VSP-37
July 7, 1982

VENDOR SERVICE PUBLICATION

To: All Piper Distributors and CORPAC's
Subject: Bendix Service Bulletins 615, 620, 621

Figure 1. 10-157197 Distributor Gears with Different Timing Marks

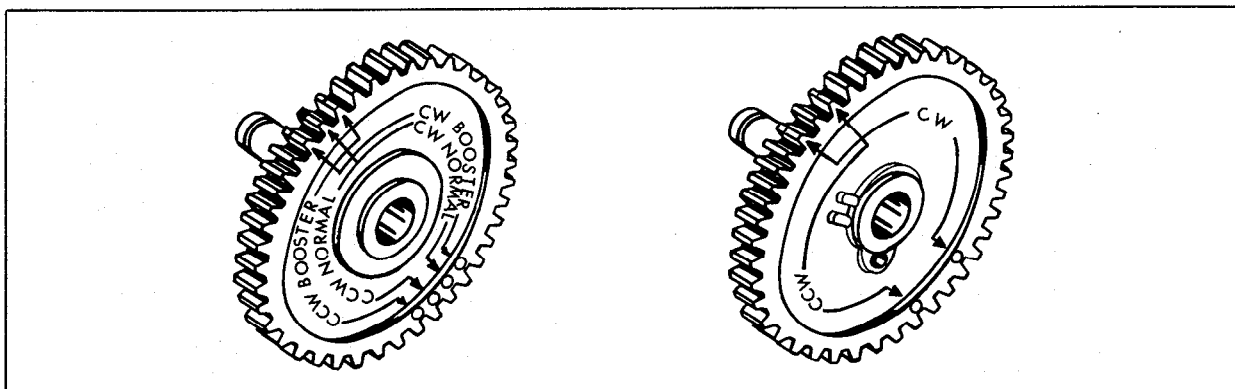
2. If old distributor gear, P/N 10-157197, which incorporated two different molded timing identification marks was used (see figure 1), proceed as follows:

- Remove paint from booster timing positions with suitable solvent.
- Locate normal timing tooth between CW and CCW booster chamfered teeth and paint this tooth and the applicable inner timing mark with red Dykem or red lacquer in accordance with figure 2 or figure 4 for appropriate gear.

Figure 3. Timing Marks on Present Production Distributor Gear Kit Assembly 10-357586

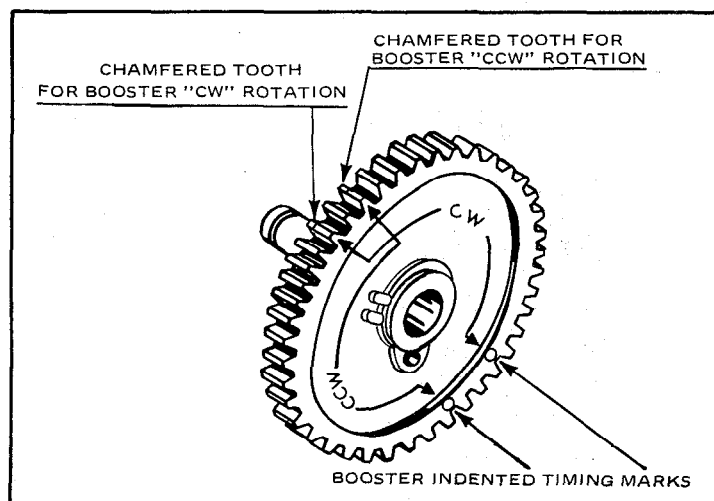
3. If present production distributor gear as supplied in kit P/N 10-357586 is used (see figure 3) proceed as follows:

- Remove paint from booster timing positions with suitable solvent.
- Locate normal timing tooth between CW and CCW booster chamfered teeth and paint this tooth and the applicable inner timing mark with red Dykem or red lacquer in accordance with figure 4.

Figure 4. Present Production Distributor Gear Assembly with Additional Timing Marks Painted

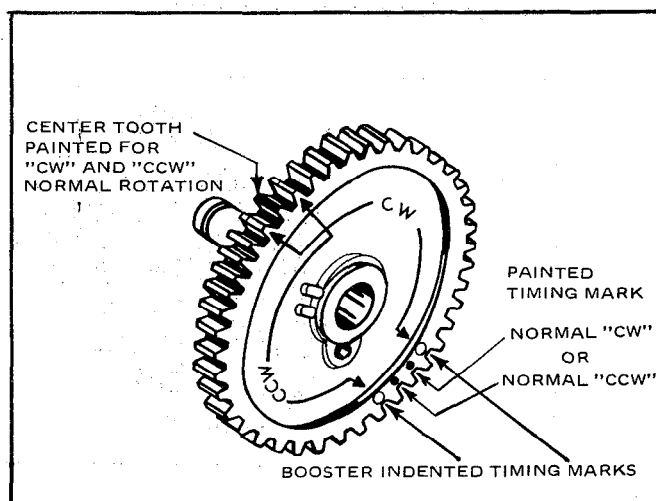
The molded timing marks incorporated in new present production nylon spare part gears, as supplied in kit, P/N 10-357586, are for the booster timing position. Before installation of a new gear kit, the applicable normal timing mark and center tooth must be marked with red

Dykem or red lacquer as illustrated in figure 4.

- Reassemble the magneto using the applicable **normal** timing mark on distributor gear.
- After magneto has been reassembled, identify the magneto by stamping the letter "R" in the upper left hand corner of the identification plate using a $\frac{1}{16}$ inch metal stamp.
- Make an appropriate engine Log Book entry indicating that this Service Bulletin has been complied with, recording magneto serial number.

Original Gear Make Up
(Not incorporating insulating or plain steel skid washer.)
Figure 1

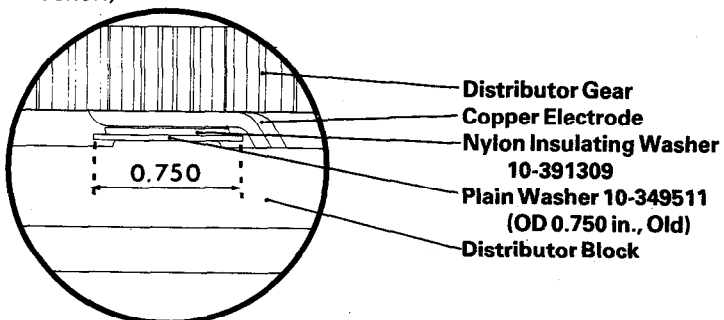
1. Remove the top timing plug.
2. Using a concentrated light beam (a pen light or equivalent) look into the timing hole at the area between the distributor gear and the distributor block parts for existing washer configuration.
3. Current configuration should be as shown in figure 3.
4. Rework magneto whenever configuration is as shown in figure 2.
5. An acceptable configuration is shown in figure 1.

Insulated Gear Configuration
(Incorporating 10-357586 Kit parts with *incorrect* washer.)
Figure 2

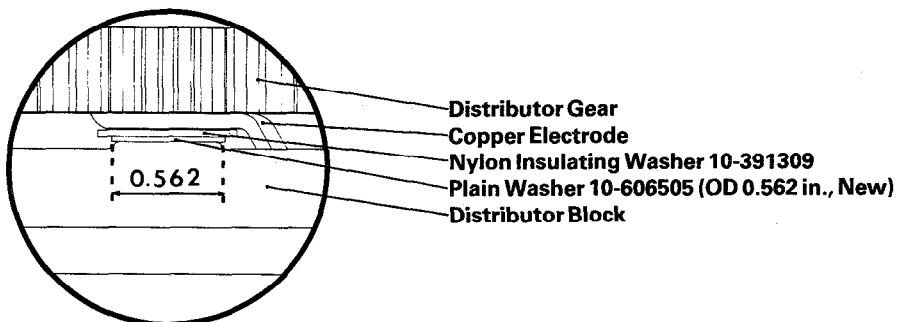
It has been determined that plain steel washer P/N 10-349511 installed on the gear axle between the nylon insulating washer P/N 10-391309 and the distributor block bronze oil-lite bushing (see figure 2) can cause electrical flash-over in the distributor at altitude. Inspect for compliance as follows:

Rework a magneto to the correct configuration as follows:

1. Remove magneto from engine.
2. Disassemble as required using procedures described in Bendix Overhaul Manual Form No. L-205-10 for S-20 and L-527-4 for S-200 series magnetos.
3. Remove retaining ring and plain washer. Discard retaining ring. Remove distributor gear from the distributor block.
4. Inspect the distributor block for burning or carbon tracking and serviceability. Replace if defective.
5. Remove old plain steel washer P/N 10-349511 (OD 0.750 in.) and nylon insulating washer P/N 10-391309 from the gear axle.
6. Reinstall nylon insulating washer P/N 10-391309 and install new plain washer P/N 10-606505 (OD 0.562 in.) on gear axle. See figure 4 for assembly order.
7. Wipe distributor gear axle clean, then reinstall it in the block. Place plain washer P/N 10-349511
